Subject: S.P. 2774-27504A  
Bridge No. 27504  
Revised Plan Sheets

Subject: S.P. 2774-16  
Bridge No. 27504  
Revised Plan Sheets

## Addendum 1 for changes to the Plans and Special Provisions for Bridge Nos. 7268 and 27504:

DES: RJR DR: RLS APPROVED: 5/29/13  
 CHK: GBB CHK: TRS  
 SHEET NO. 22R OF 34 SHEETS

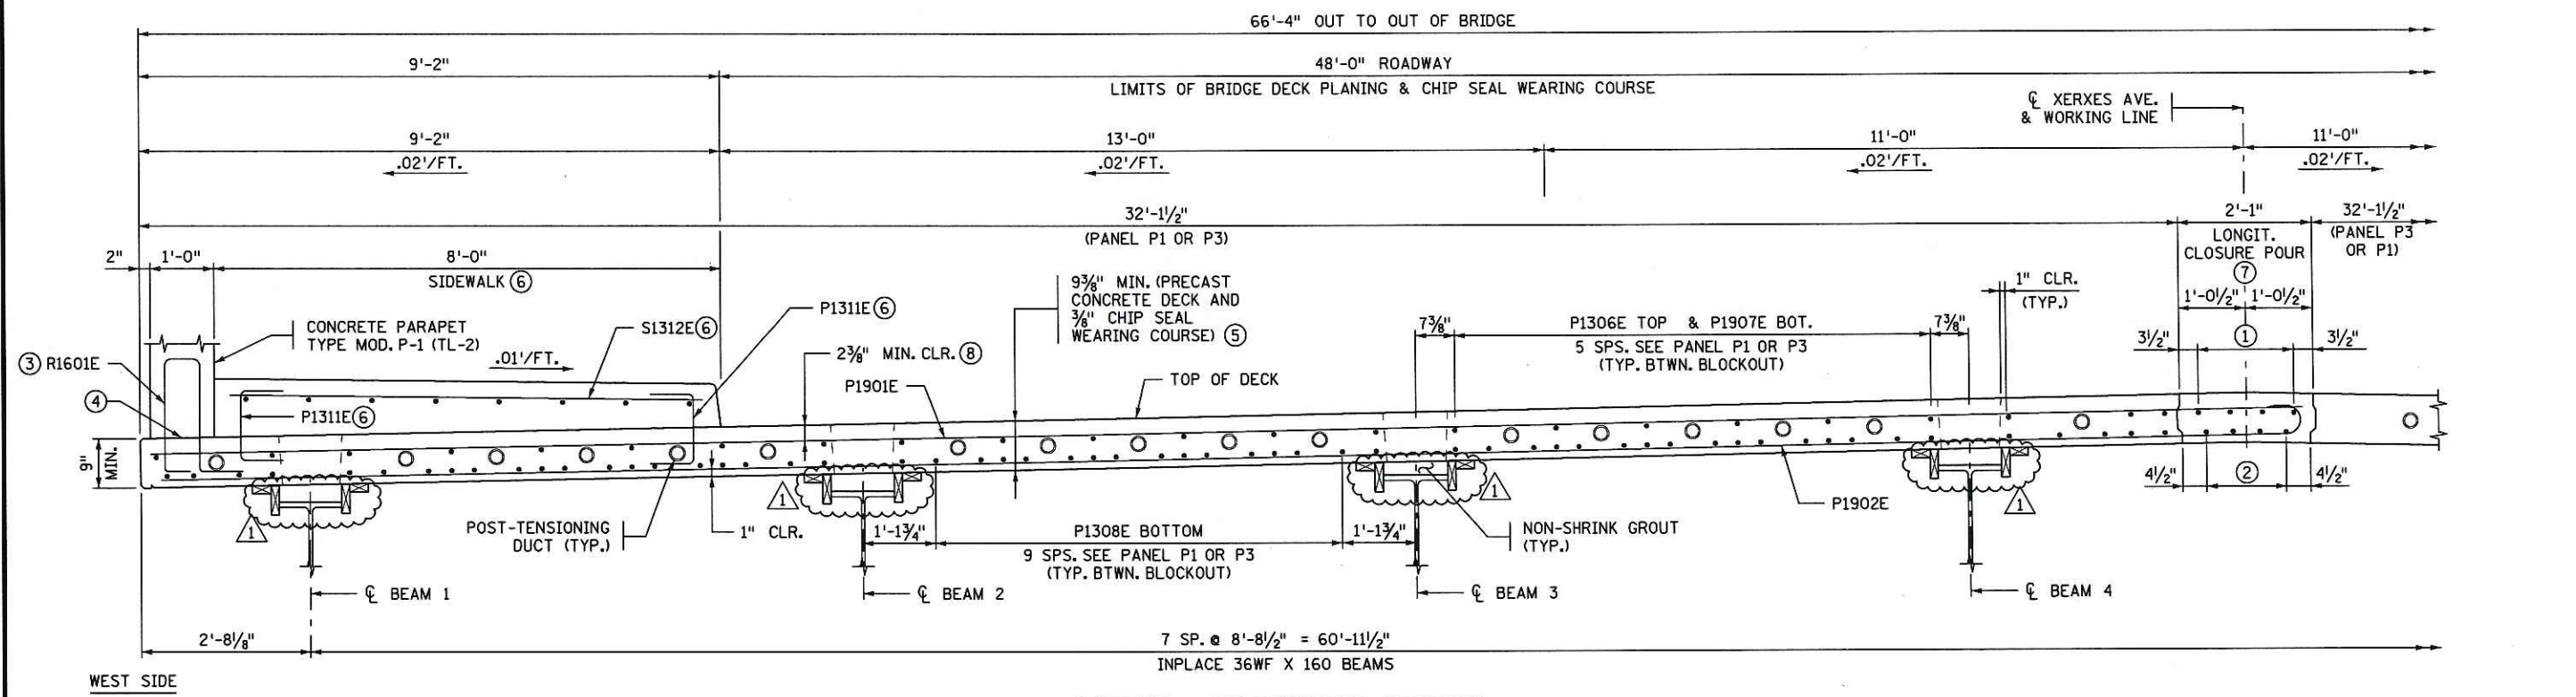
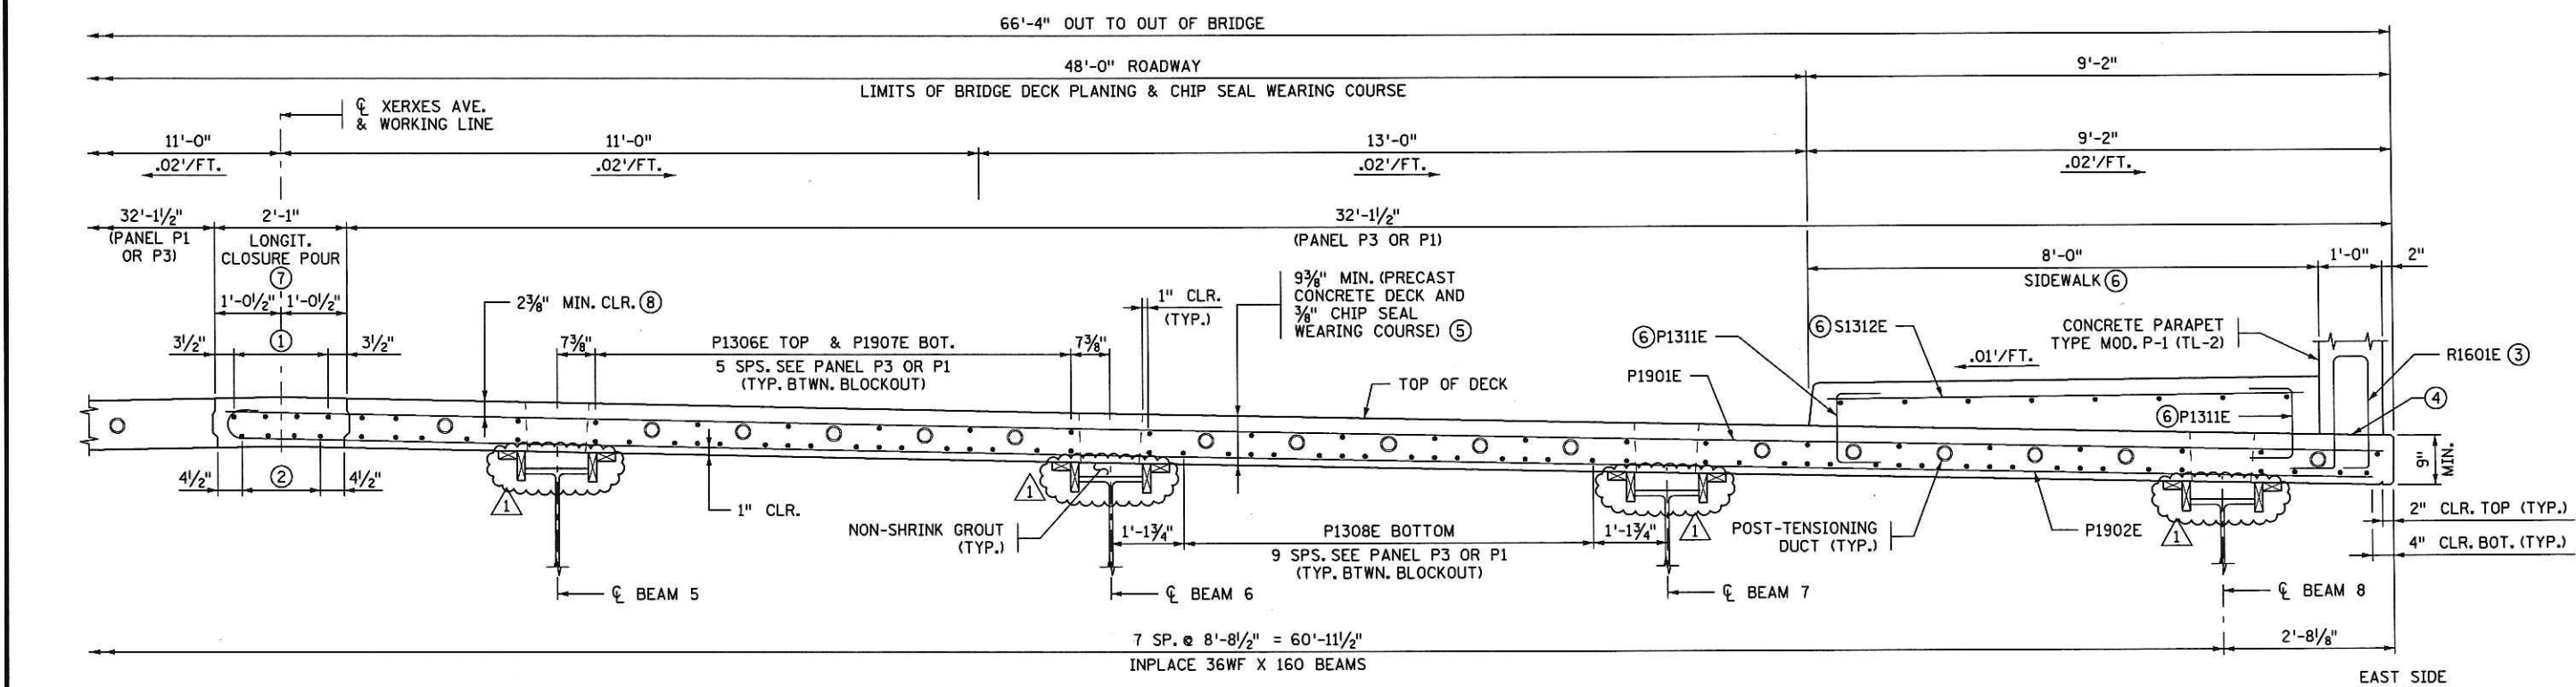
22) On Sheet 22R of 34 for Bridge No. 27504 the following changes were made:

- a. Revised haunch forming scheme.

DES: RJR DR: BEP APPROVED: 5/29/13  
 CHK: GBB CHK: TRS  
 SHEET NO. 24R OF 34 SHEETS

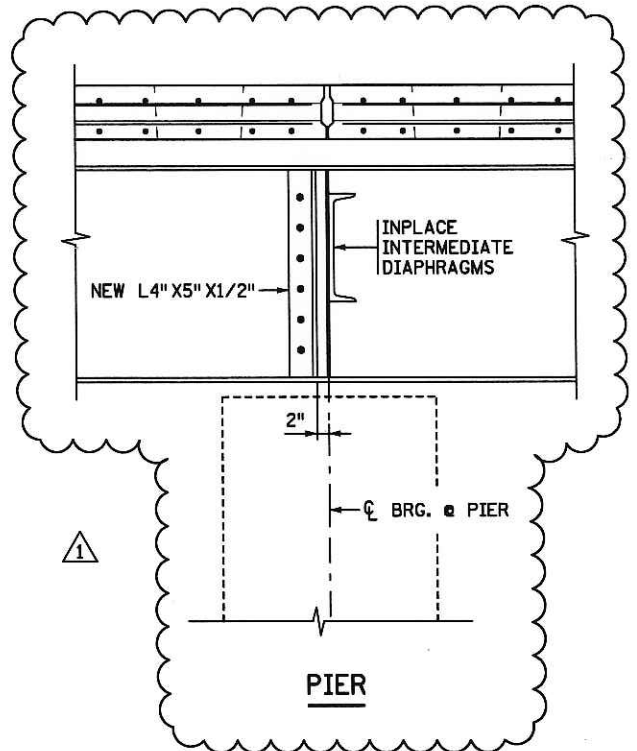
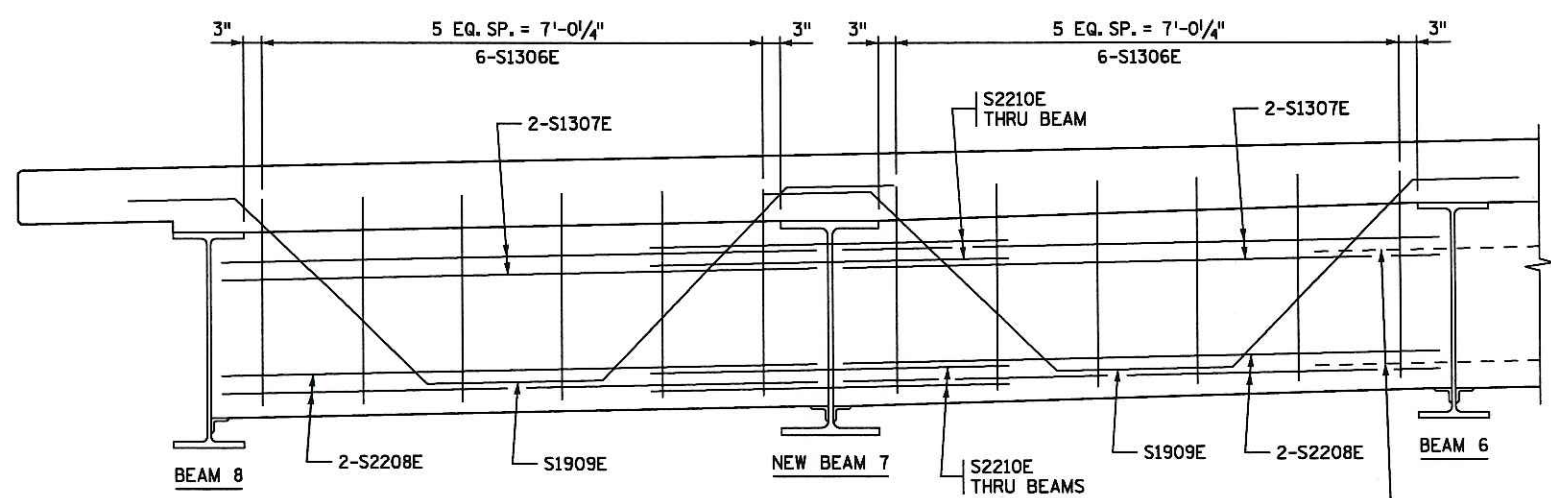
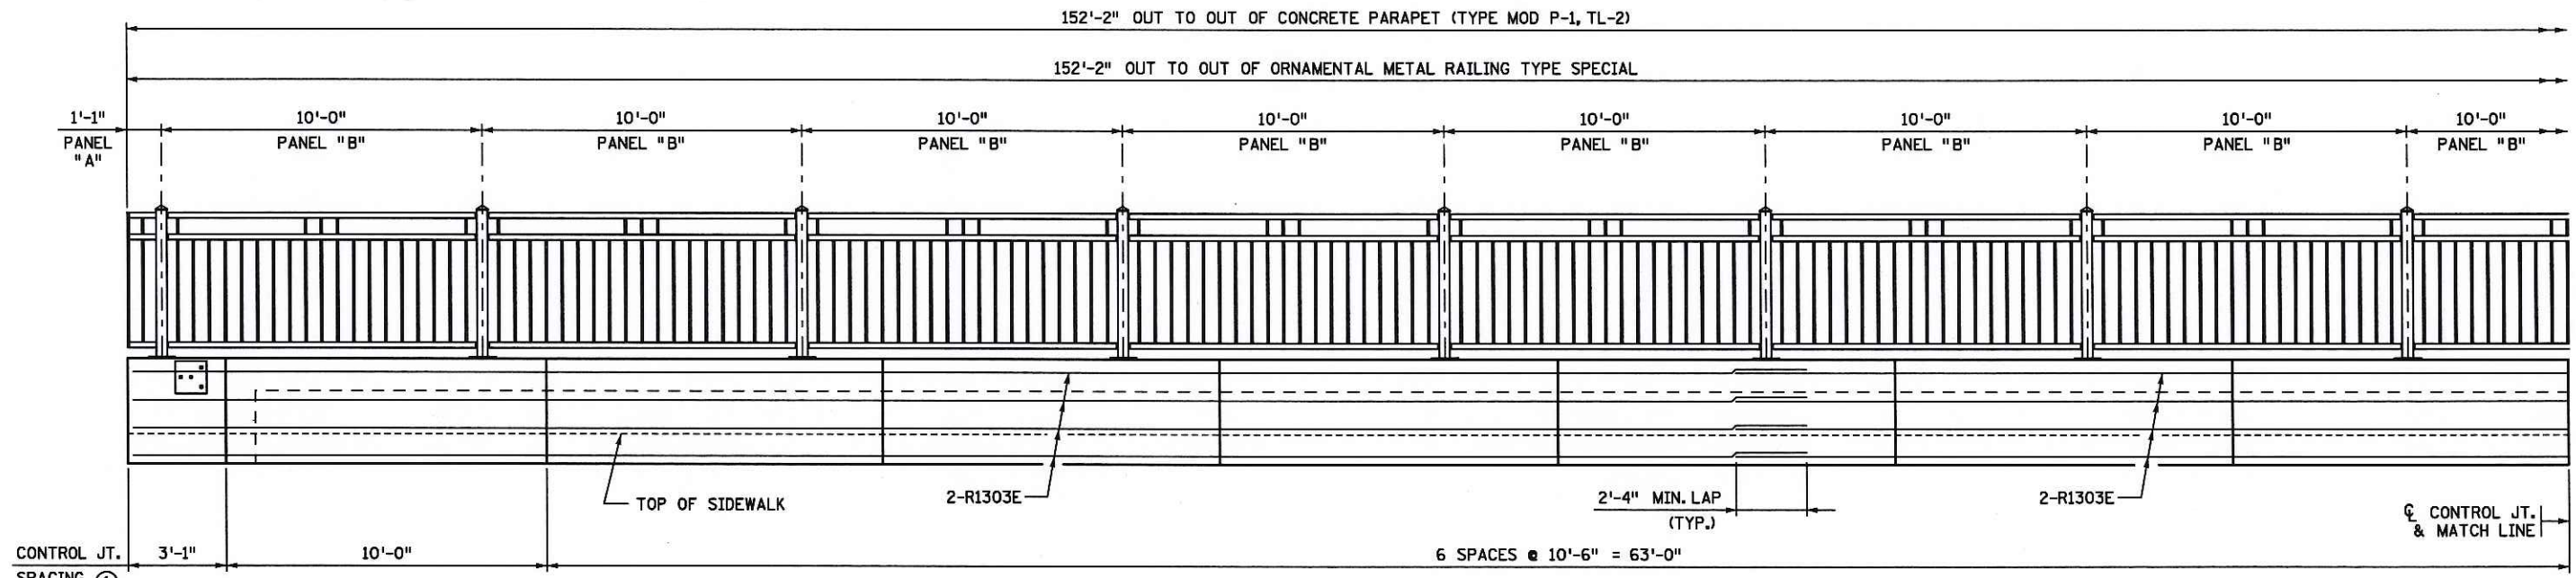
23) On Sheet 24R of 34 for Bridge No. 27504 the following changes were made:

- a. Added longitudinal section at pier.

Revised Rail Rustication

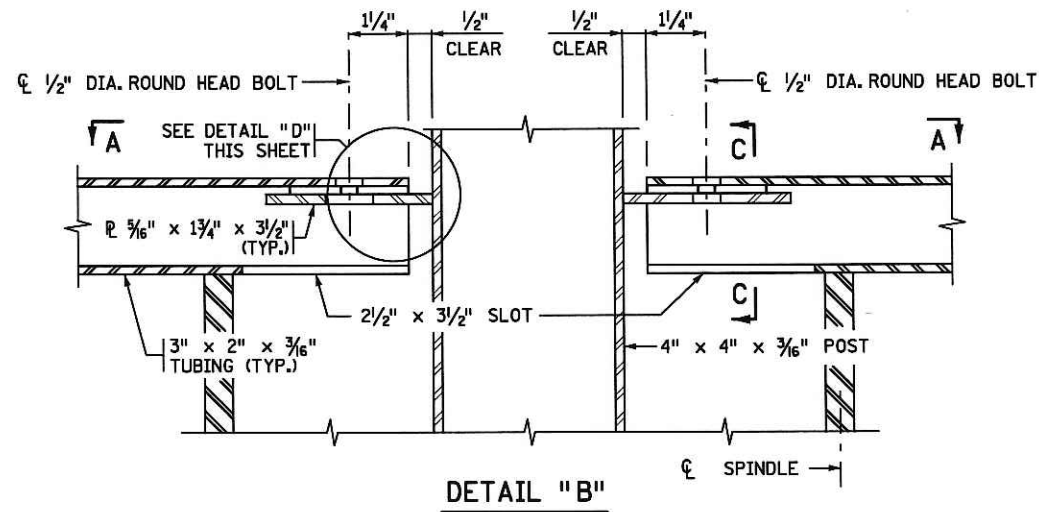
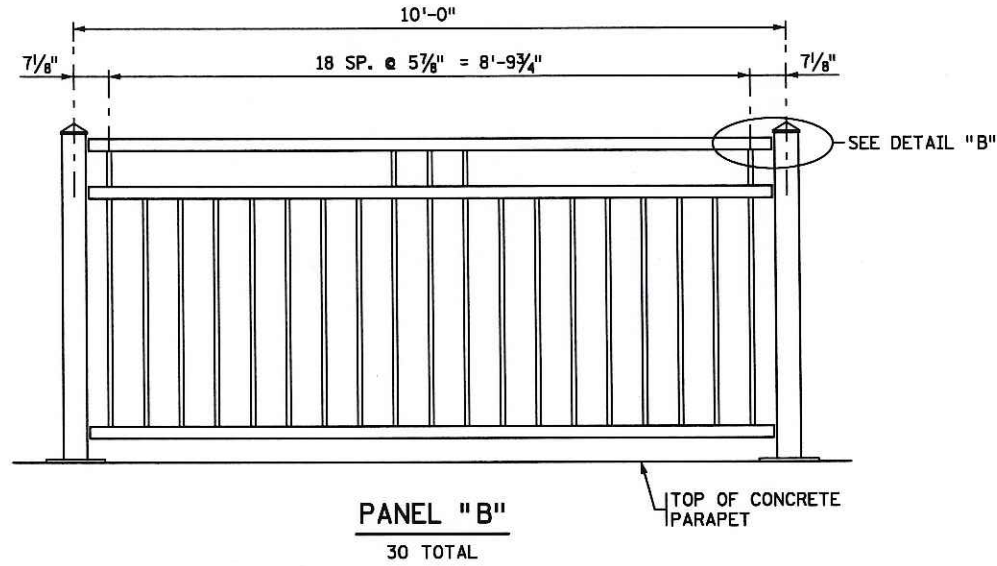
24) On Sheet 26R of 34 for Bridge No. 27504 the following changes were made:

- a. Revised rail rustication from  $\frac{3}{4}$ " to  $\frac{1}{2}$ ".
